RE: Camas Woods Development (SUB24-1002) Completeness Review Response

This letter is written as a response to the Completeness Review Letter issued December 11, 2024. Each item from the completeness letter will be listed below in italics, with a response following the item.

LAYOUT 11
CAMAS WOODS
HSR CAPITAL
CITY OF CAMAS, WASHINGTON

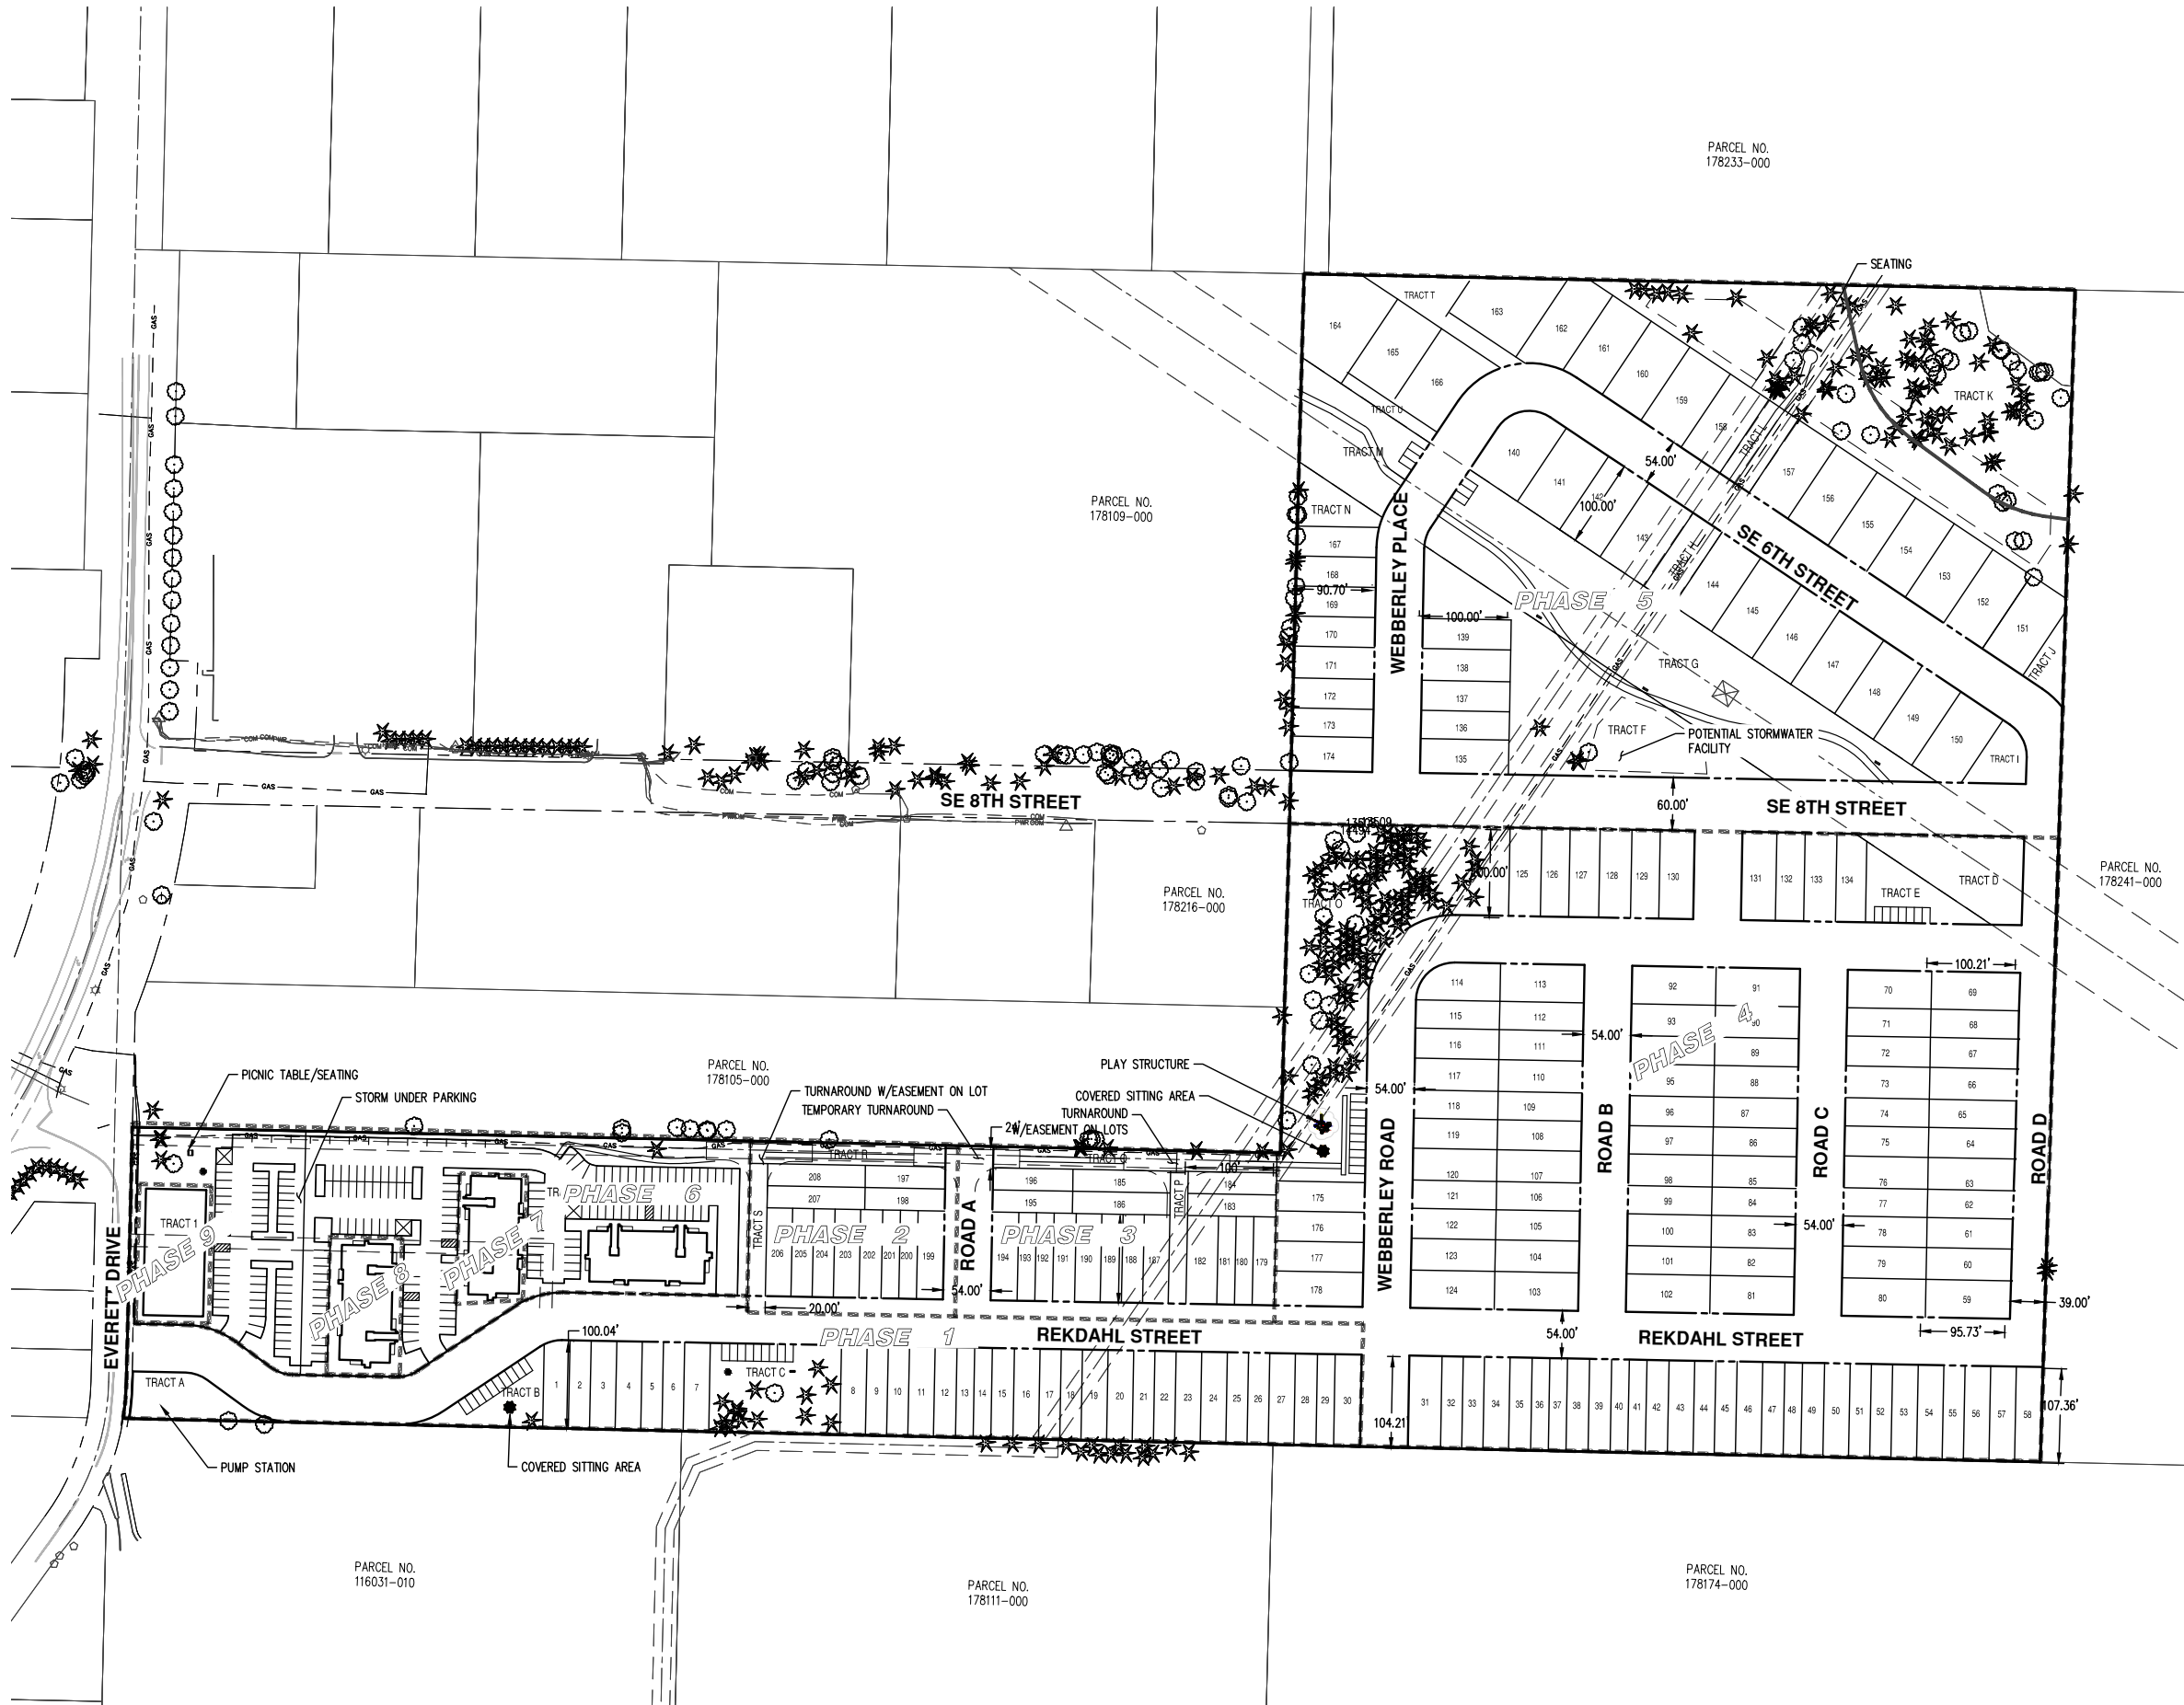
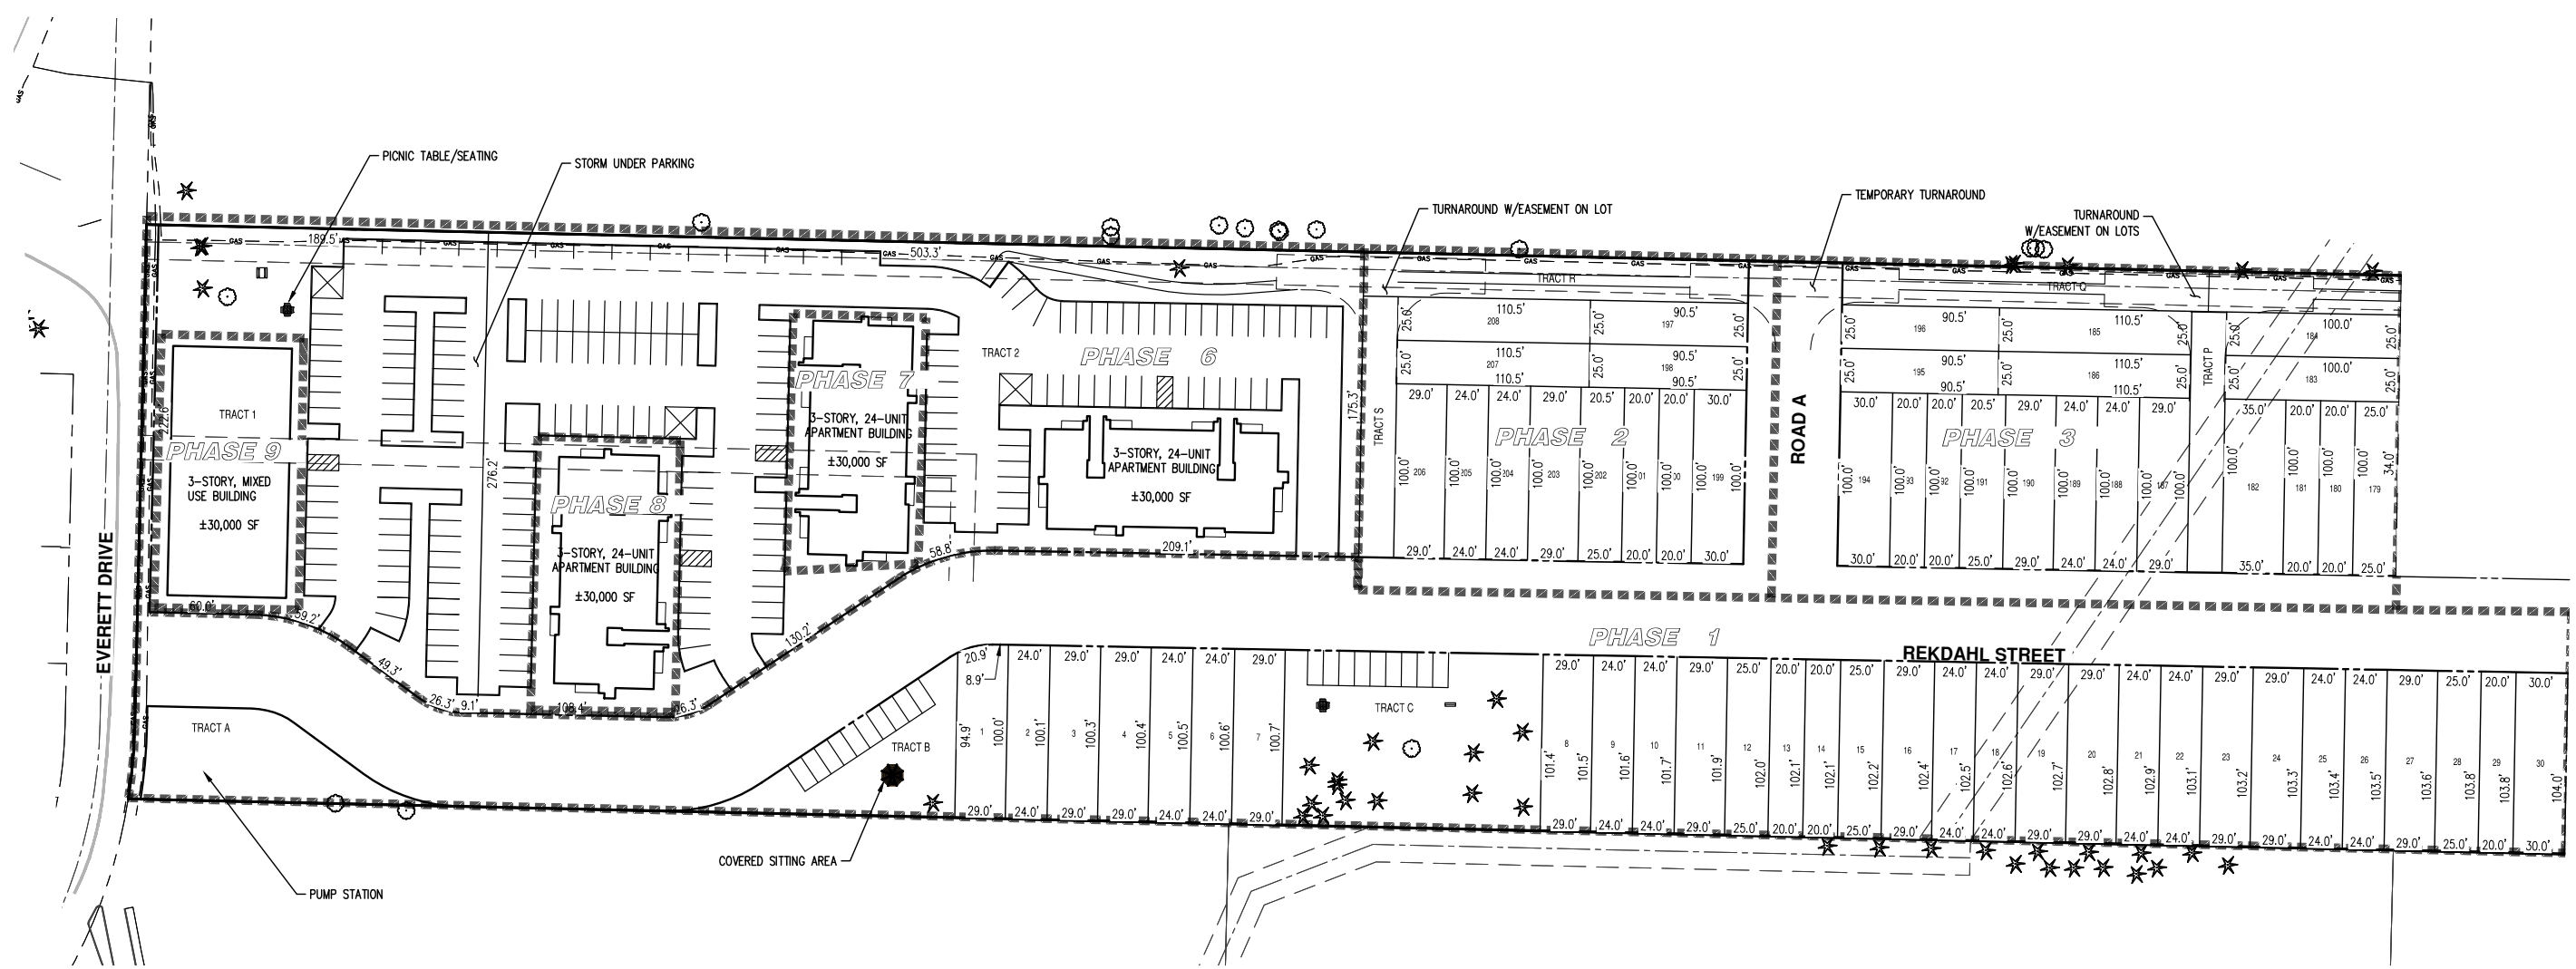
From: [Curleigh \(Jim\) Carothers](#)
To: andreottim@aks-eng.com
Cc: [Anita Ashton](#); [Randy Miller](#); [Robert Maul](#); [Madeline Sutherland](#)
Subject: RE: Camas Woods - Turnarounds on 150"+ Streets (Road A, Tracts P and S)
Date: Thursday, February 1, 2024 2:12:47 PM
Attachments: [image002.png](#)
[image003.png](#)
[image004.png](#)
[image005.png](#)
[8397_20240112_Camas_Woods_Updated_Plans.pdf](#)

Based on conversation in the Tuesday virtual meeting regarding your request to eliminate turnarounds for Road A, Tract P and Tract S, please find attached the response from the Fire Marshal's Office.

Curleigh, this is in response to our discussion about the Camas Woods project and their request for a compromise on turnarounds. When the distances, as in this case, are minimally longer than 150 feet the FMO has offered mitigation options that include additions to the life safety fire sprinkler systems already being installed. These additions include adding fire sprinkler coverage in areas not normally required in 13D.... All bathrooms, All closets, All garages and any other space not normally required by 13D, (excluding attics and crawl spaces unless gas fired appliance coverage dictates otherwise). These mitigation options help reduce the occurrence of significant fires requiring fire ground operations and the use of significant amounts of equipment and personnel.

There is not an easy way to track the above potential mitigation options into the future therefore approved plat notes will be required.

This compromise also seeks more spacious width access drives to provide effective police, fire, medical services to the homes at the end of these access drives.
